DESIGN AND CONSTRUCTION MANUAL DESIGN MODIFICATION REQUEST

PROJECT NAME: The Retreat at Hook Farms 2nd Plat

Re: The Retreat at Hook Farms Second Plat-Stream Buffer Variance Request

Re: The Retreat at Hook Farms Second Plat – PL2021165
 Stream Assessment Design Memorandum

RETREAT AT HOOK FARMS SECOND PLAT

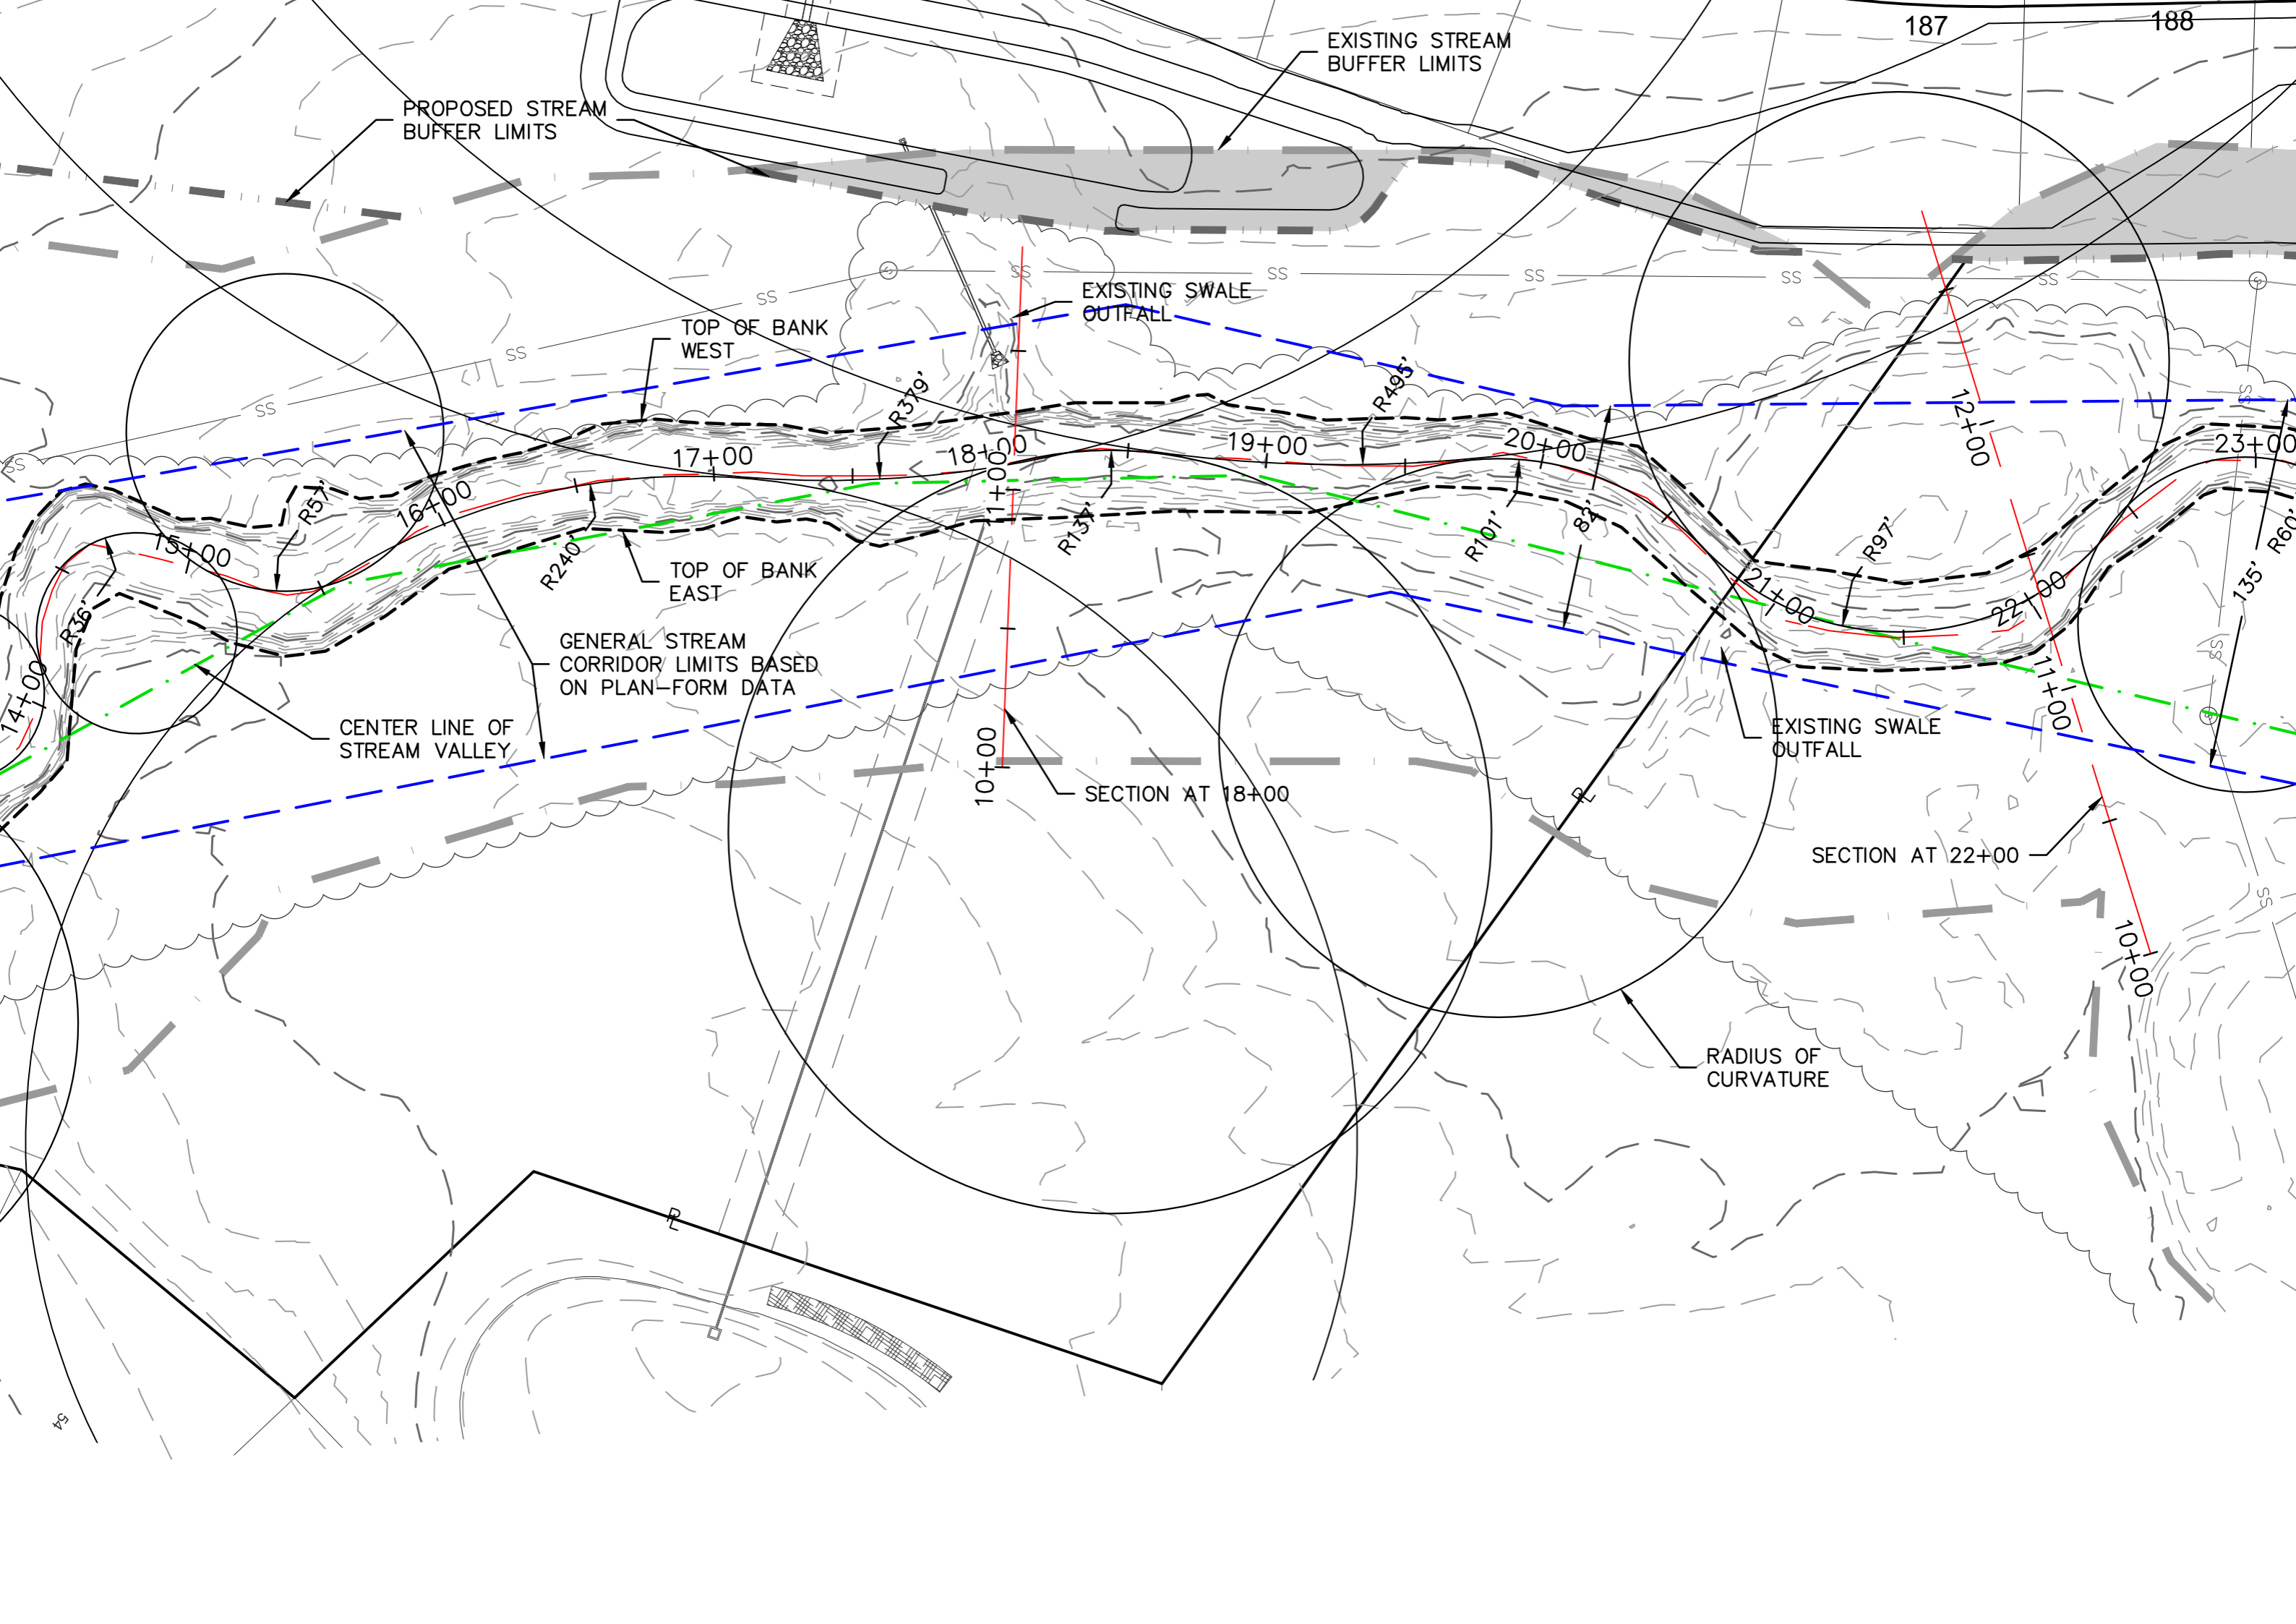
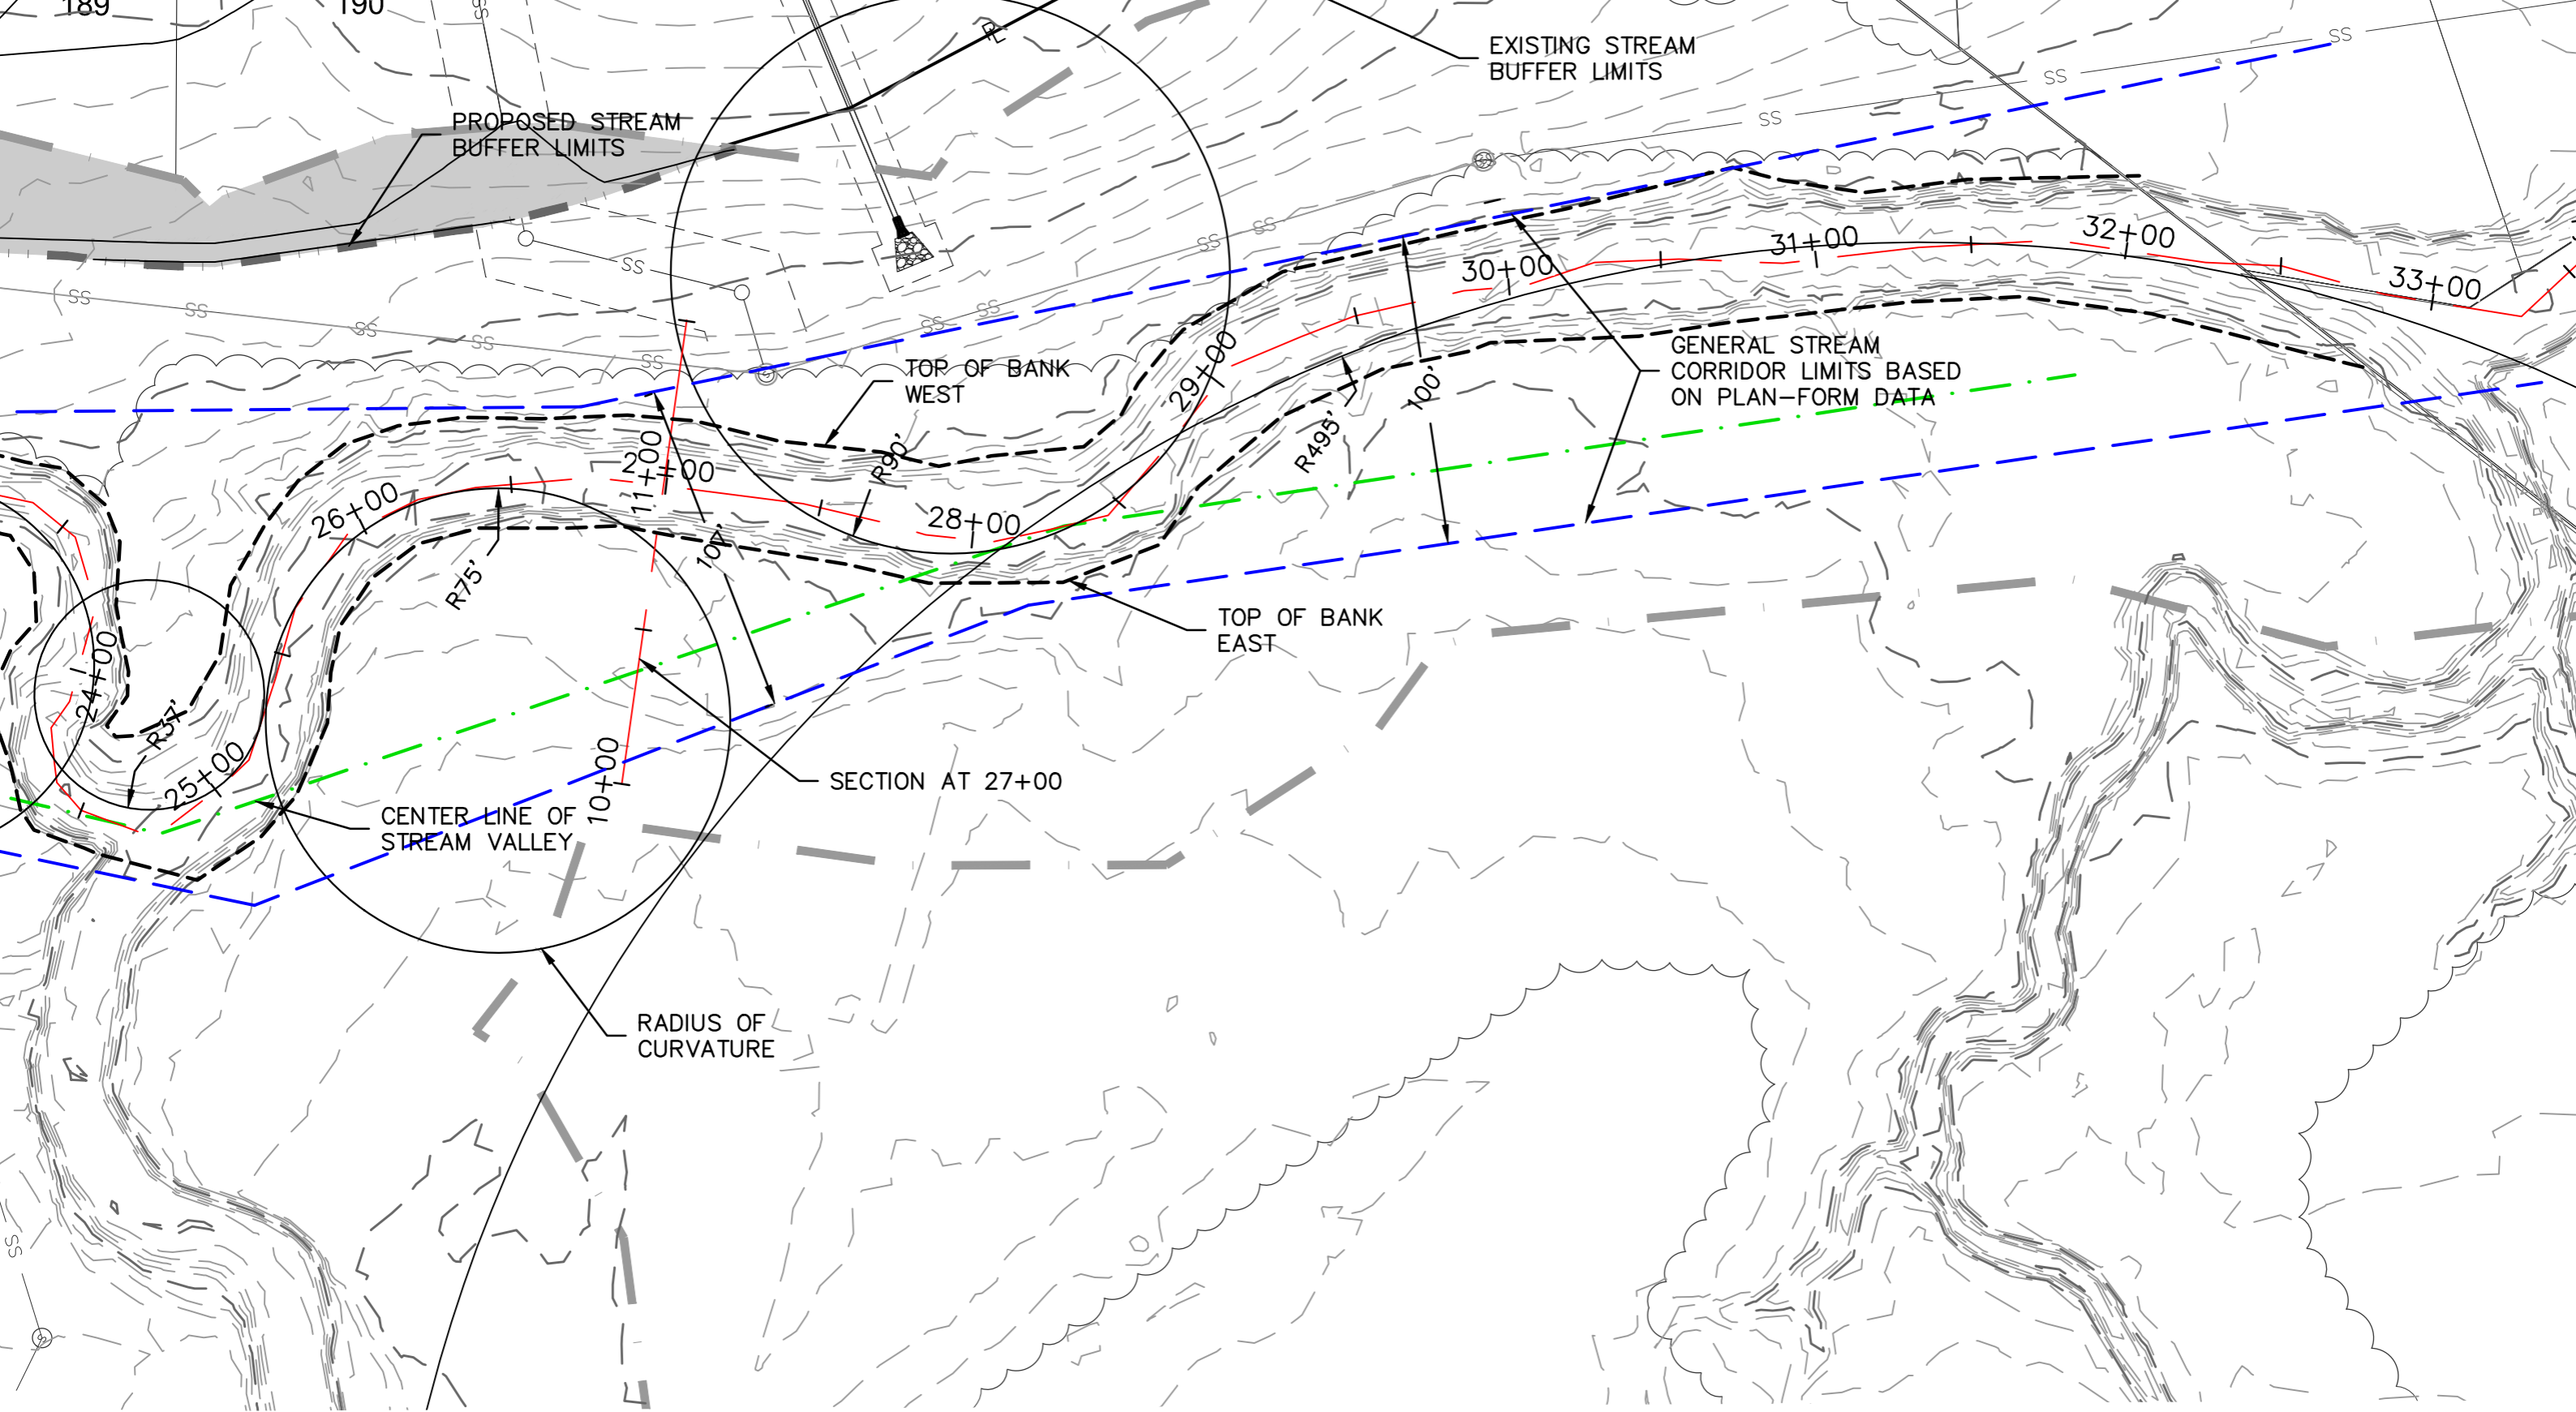
Based on the plan-form analysis, general steam corridor limits have been shown on the Stream Assessment Plans. The stream corridor limits show that the proposed development will not interfere with the natural meandering of the stream.

In conclusion, the purpose of the stream setback is to ensure there is sufficient space for the stream to meander in a natural manner. The Plan-Form Analysis demonstrates that the proposed development will not interfere with the natural movement of the stream channel. The HGL and shear stress analysis also demonstrate minimal impact. In addition, the proposed development will also not cause any channel constrictions within the flow level of the 100-year storm.
